General Advisory

PowerG Wireless Vanishing Door/Window Contact with Firmware Version 1.07

Date: July 22, 2019

Product: PowerG Wireless Vanishing Door/Window Contact (PG9303)

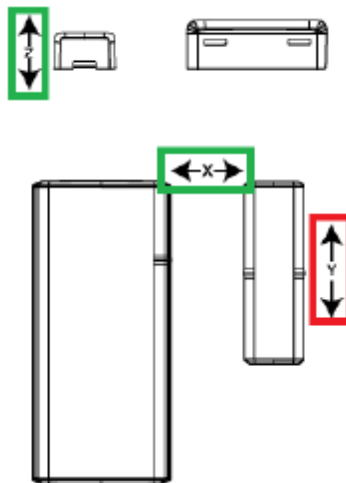
A. To resolve the reed switch issue, an updated version of PG9303 firmware was developed, and has begun shipping. This new version can be identified by (1) a Date-of-Manufacture of 4/1/2019 or later printed on the packaging and device; (2) F/W V1.07 printed on the packaging; 3) Serial Number on device or packaging with first four digits in the format XX19, where XX is 19 or higher. An image comparison of V1.03 and V1.07 packaging and detectors is included below to assist with this identification.

- B. If you carry stock with outdated firmware version, please ensure that the PowerG Wireless Magnetic Door/Window Contact (PG9303) is installed so that the magnet moves away from the reed switch on either the X or Z axis, shown in the images below.

To minimize the potential occurrence of the issue, the PowerG Wireless Magnetic Door/Window Contact (PG9303) must be installed vertically on a door that slides open horizontally, or horizontally on a window that slides open vertically.
